STAFF REPORT

RE: 1020 Margaret Street (permit application #TP2021-0009)

FROM: Karen DeMaria, City of Key West Urban Forestry Manager

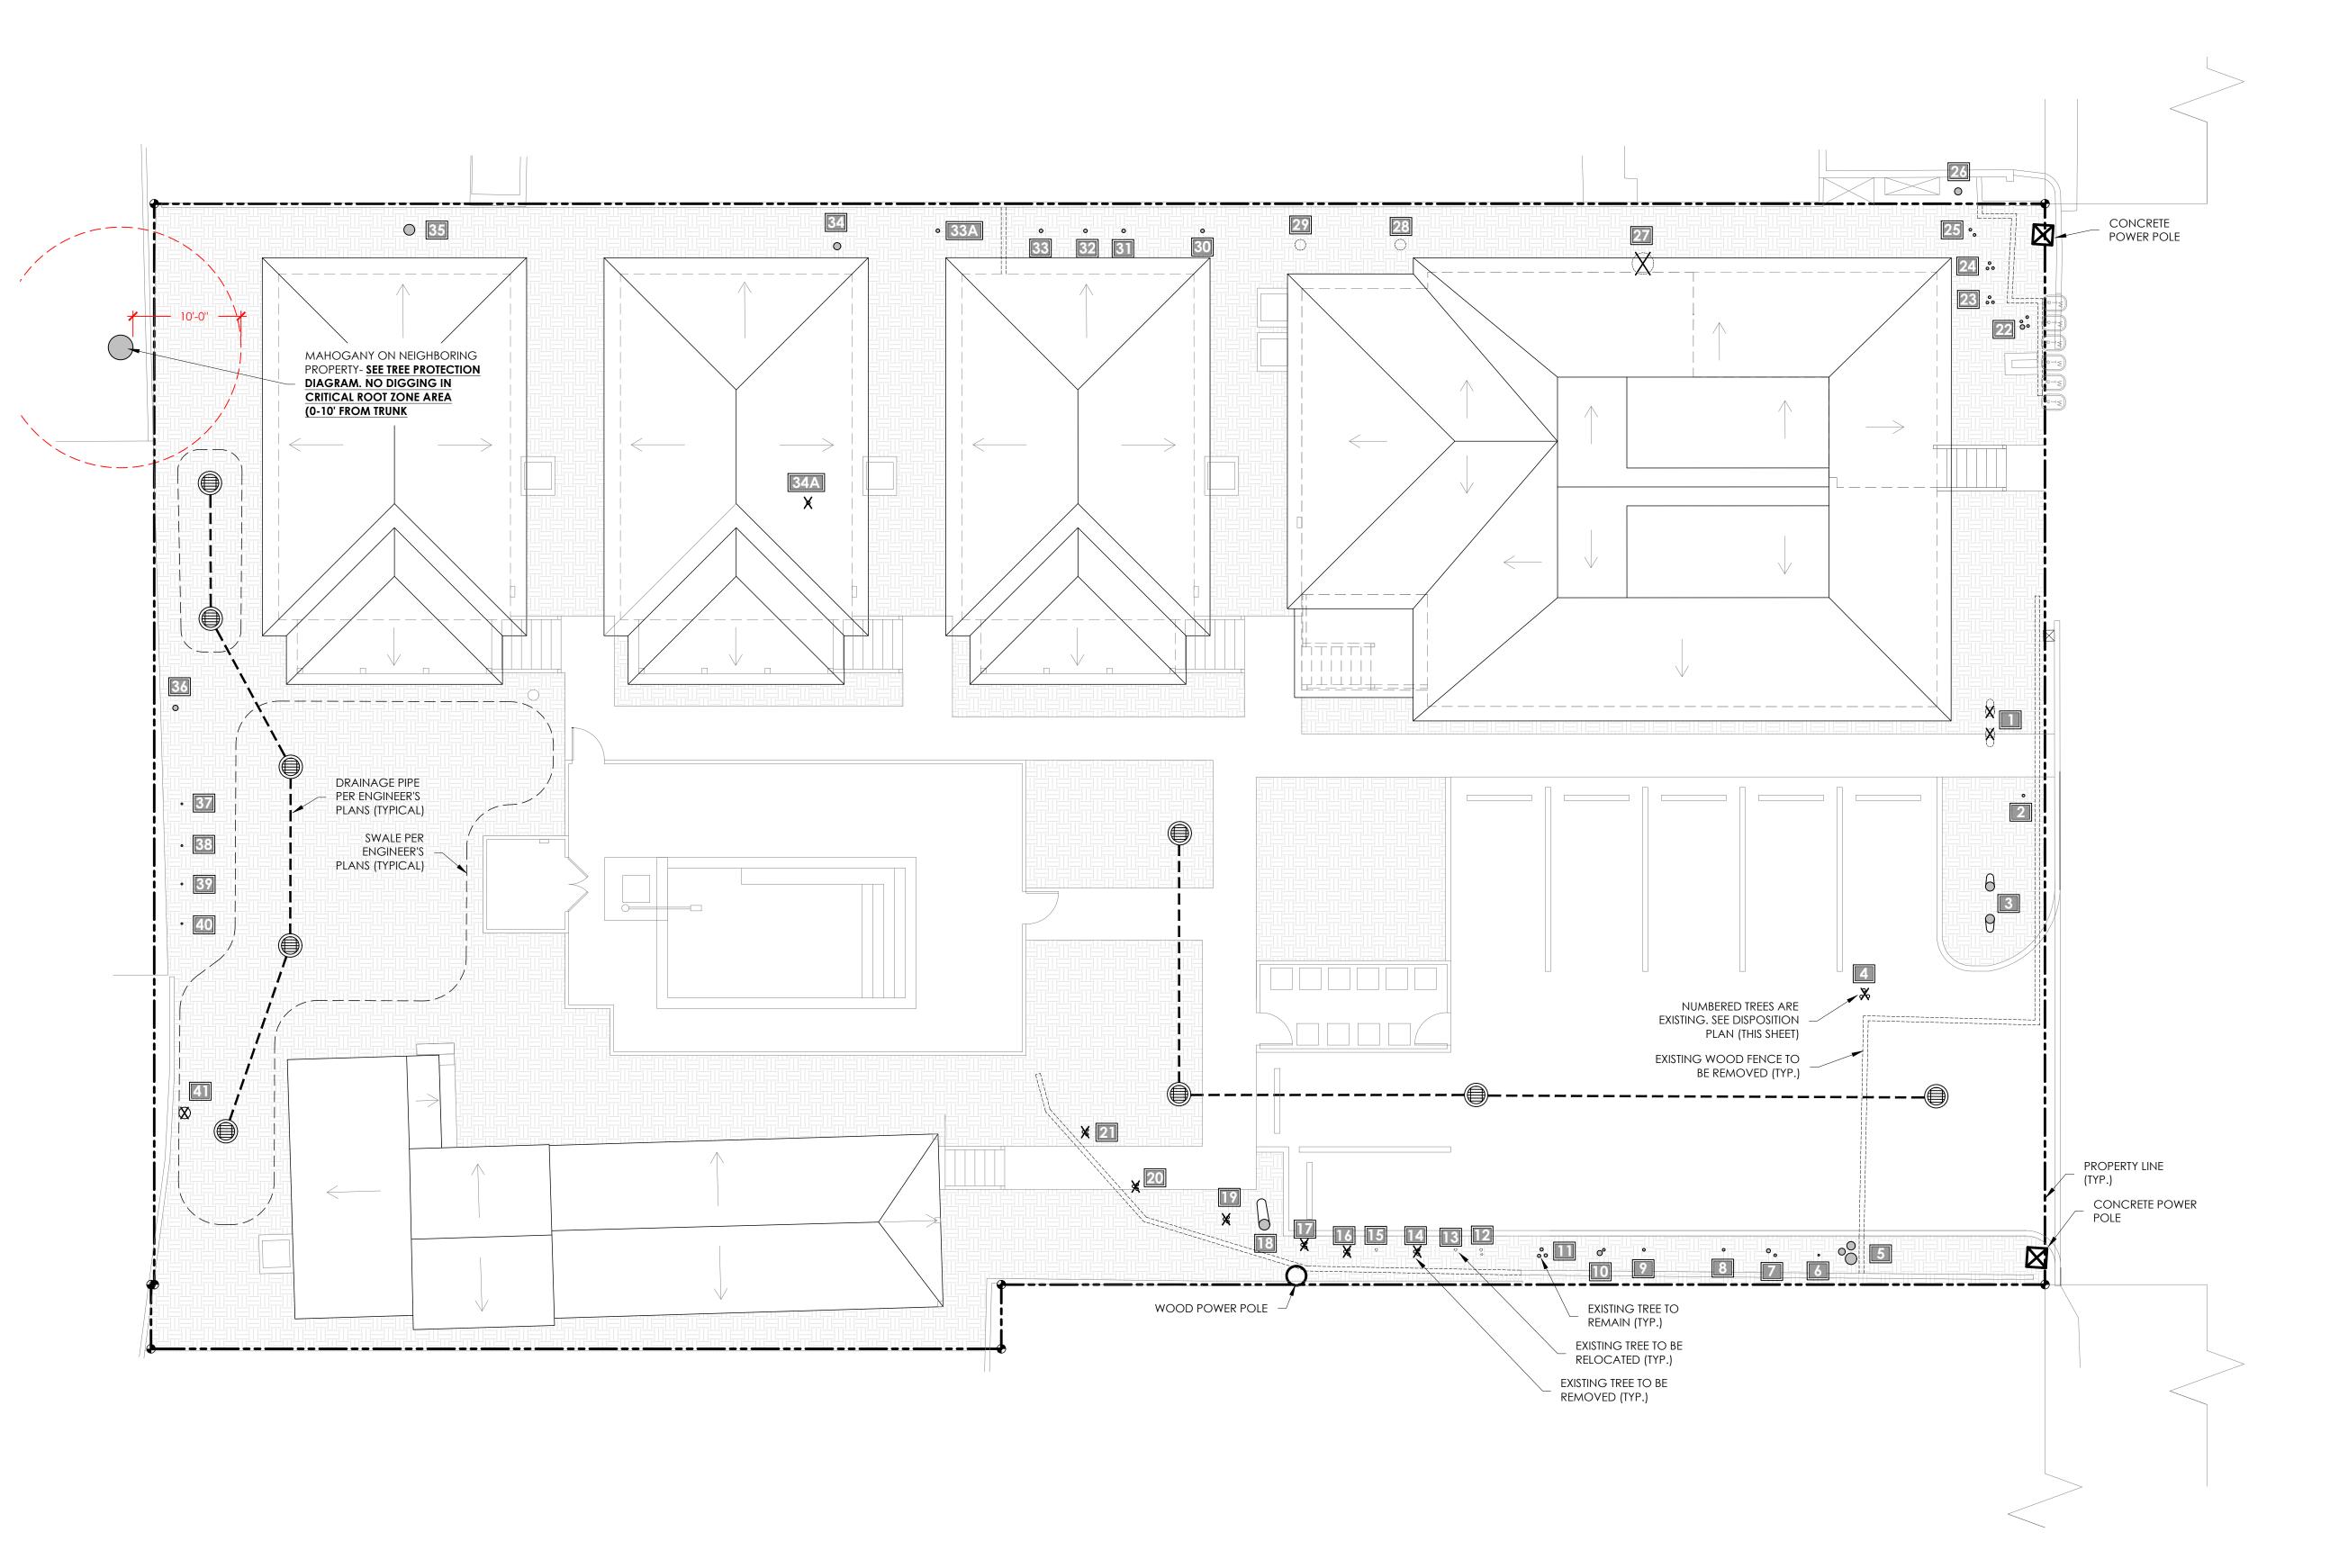
There has been a minor change to the landscape plan since conceptual landscape plan approval. The existing structure located on the left rear side of the property was originally to be moved but now will remain in place. Four Sabal Palms had originally been proposed to be planted in this area. Instead, 2-Sabal Palms and 3-Cinnamon Bark trees will be planted in the front left section of the property in a landscape buffer area.

Therefore, the Urban Forester approves of the Final Landscape Plan with tree removal, as submitted, revised plans dated July 7, 2021.

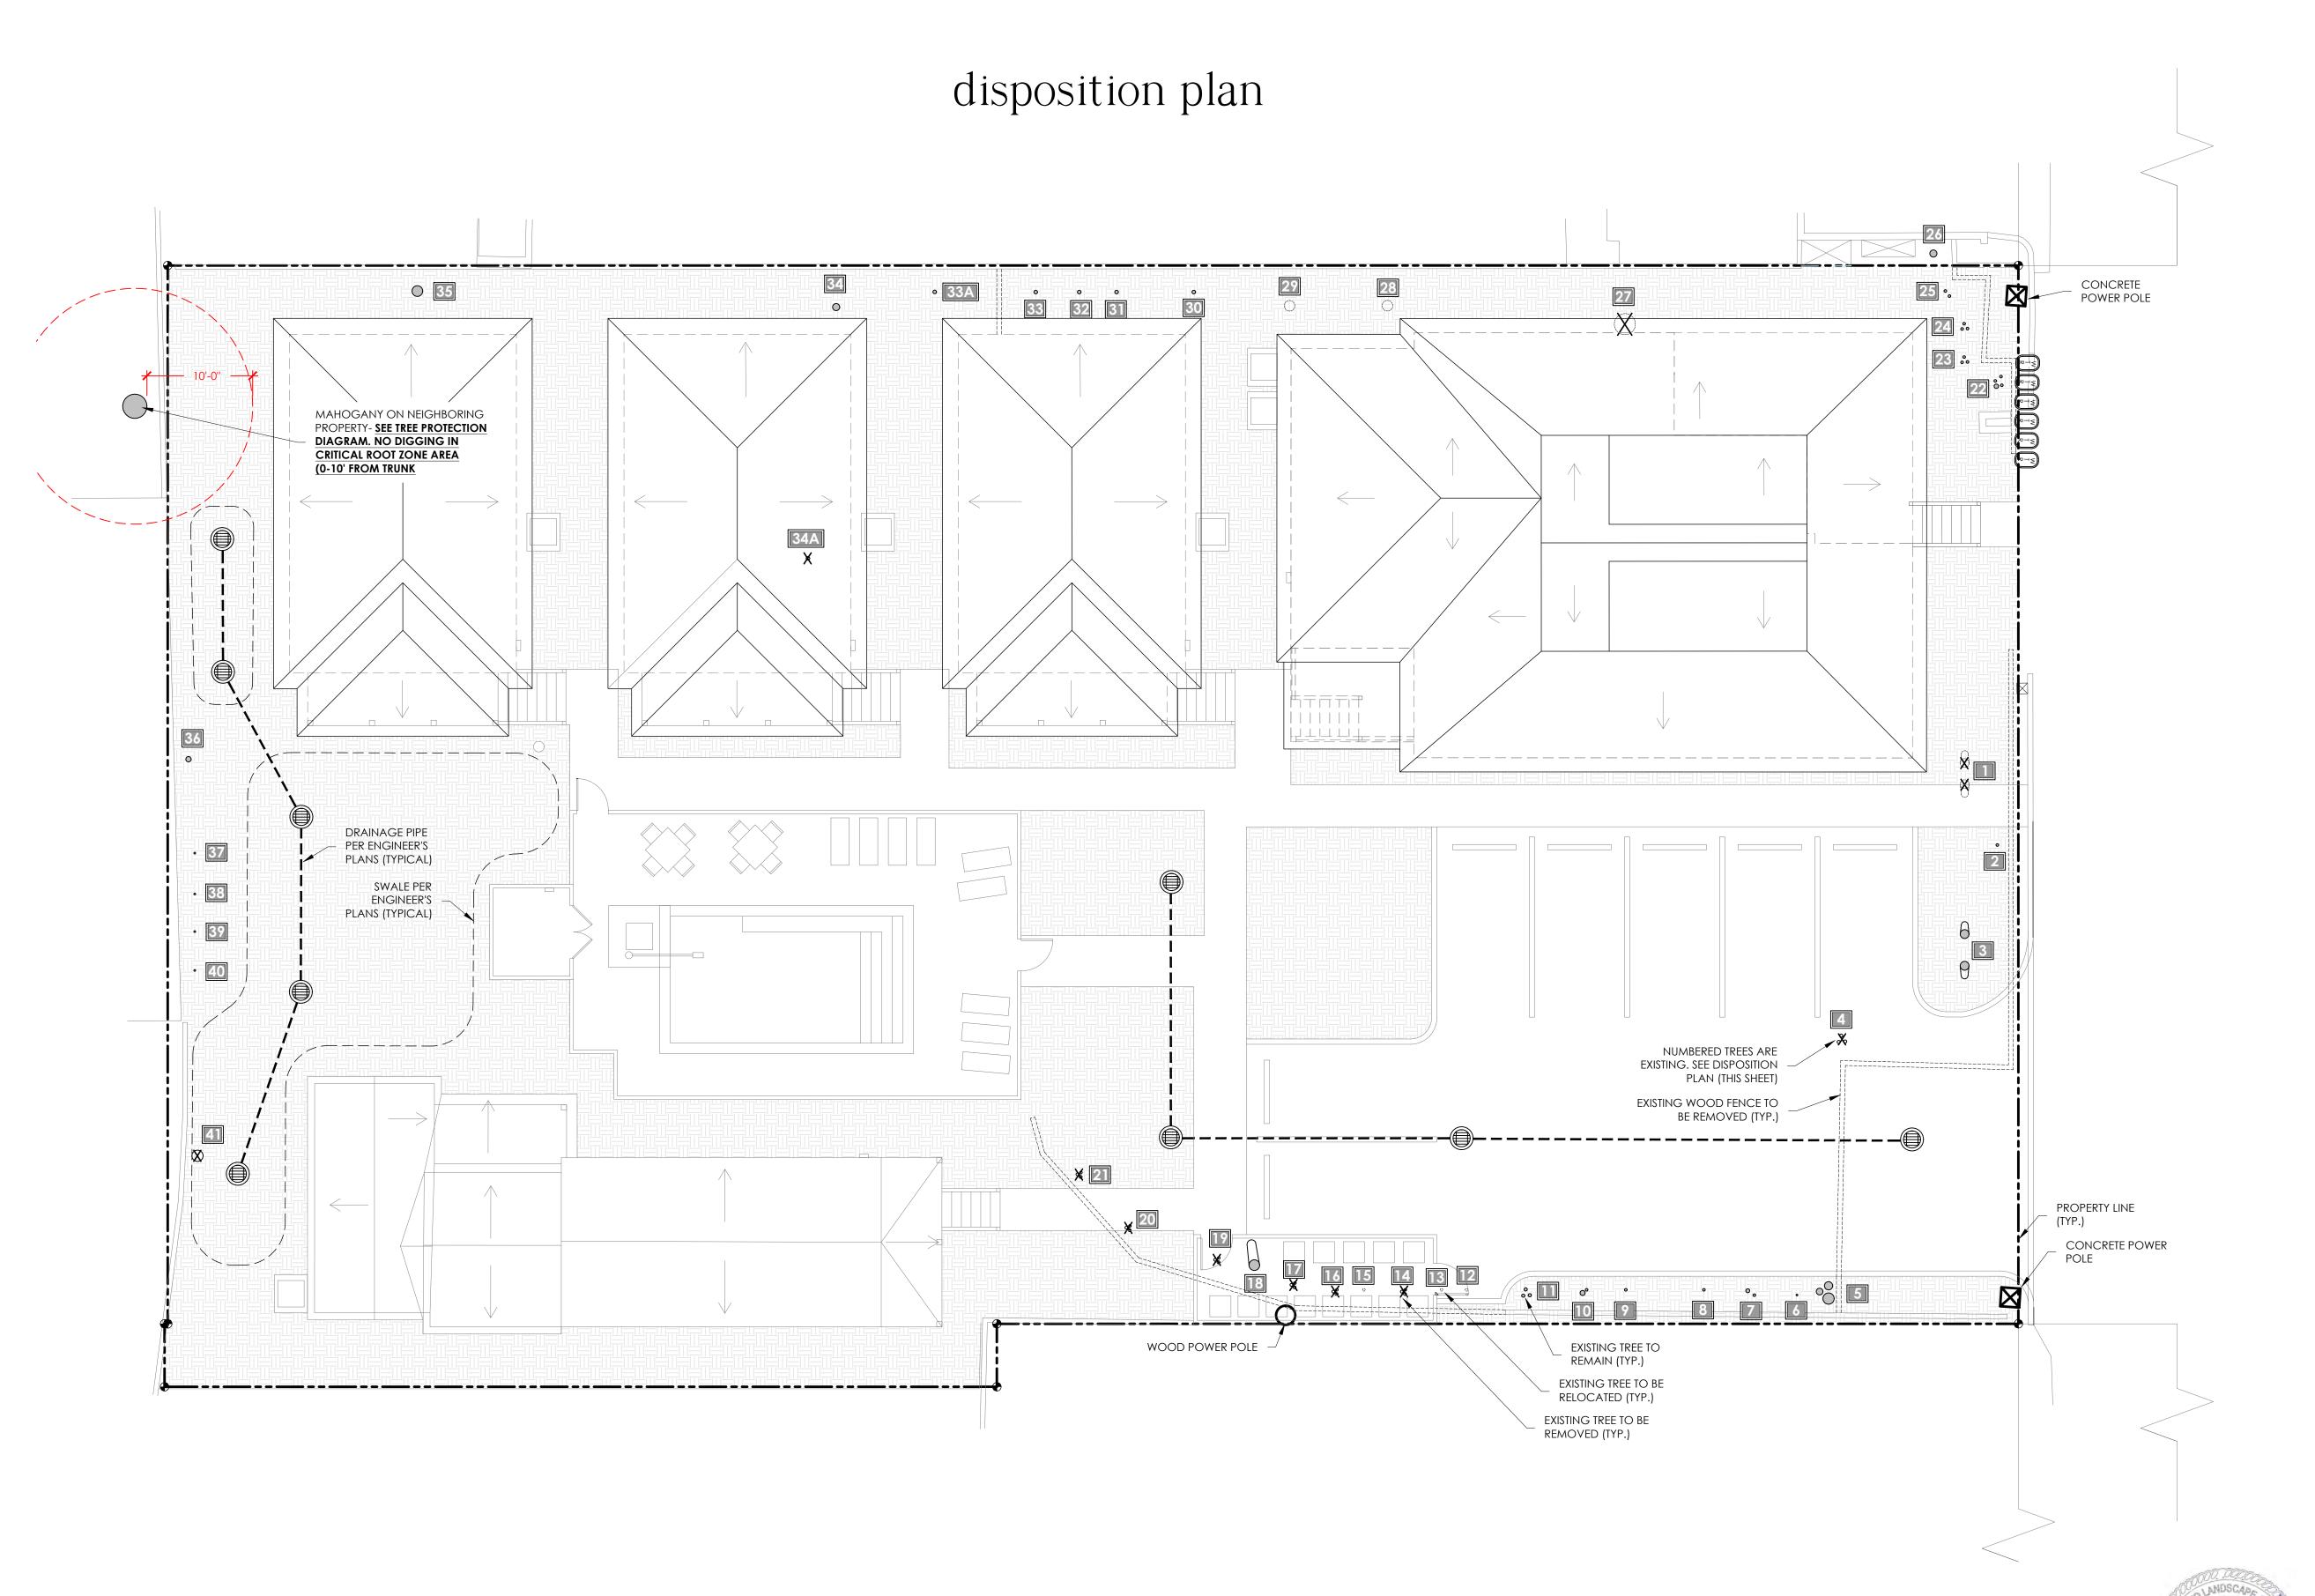
- 1. Sec 108-347 and 348, bufferyards (areas labeled 2, 3 and 4 on the plan).
 - A. Area 2 is adjacent to a hotel with Medium/High buffer requirements and is rated as a "D" bufferyard. This bufferyard requires a total of 26 plant units for the 175 linear feet of property line area and an opaque fence. A wooden, opaque fence currently exists along this property line and will remain. A total of 66 plant units (existing and new plants) are proposed for this area. This portion of the plan meets the requirements of Sec 108-347.

- B. Area 3 is adjacent to a single family zoning area. The bufferyard does not require the planting of any plant units. There is an existing wooden fence that will remain. There are currently 18 plant units existing in this bufferyard with no new plantings. This portion of the plan meets the requirements of Sec 108-347.

- C. Area 4 is adjacent to a predominately multifamily zoning area and is rated as a "B" bufferyard. This bufferyard area requires a total of 70 plant units for the 175 linear feet of property line area. A total of 76 plant units are on the plan for this bufferyard. This portion of the plan meets the requirements of Sec 108-347.

- 2. Sec 108-412. There are three existing canopy trees and numerous subcanopy trees that will be planted. The plan does incorporate over 70% native vegetation and is 24% of the property. Additional grass/groundcover is being proposed to be planted on a portion of the property in the rear that includes the swale area. The rest of the property not covered in hardscape or groundcover will be mulched or have gravel placed.

- 3. 108-413, landscape requirement along street frontages. This section of the code requires 40 plant units per 100 linear ft in a 10 ft wide landscape area. Grass and groundcover is required. Plans indicate 50 plant units of existing and new plantings will be placed along the Margaret Street frontage area in a 10 foot wide landscape bed with Purple Lantana groundcover. This portion of the plan meets the requirements of Sec 108-413.

5. Sec 108-416, interior area landscaping. This section of code specifically looks at the planting of trees and requires that all areas not covered by buildings or hardscape will have grass, groundcover, shrubs or other landscaping materials. The landscape plan proposes to place a mixture of grass, groundcover, mulch, and gravel. Based on the square footage of the area, 4 canopy trees are required for compliance to this section of the code. Three (3) Silver Buttonwood trees and (1) Paradise tree are being planted in the interior of the property. This portion of the plan meets the requirements of Sec 108-416.
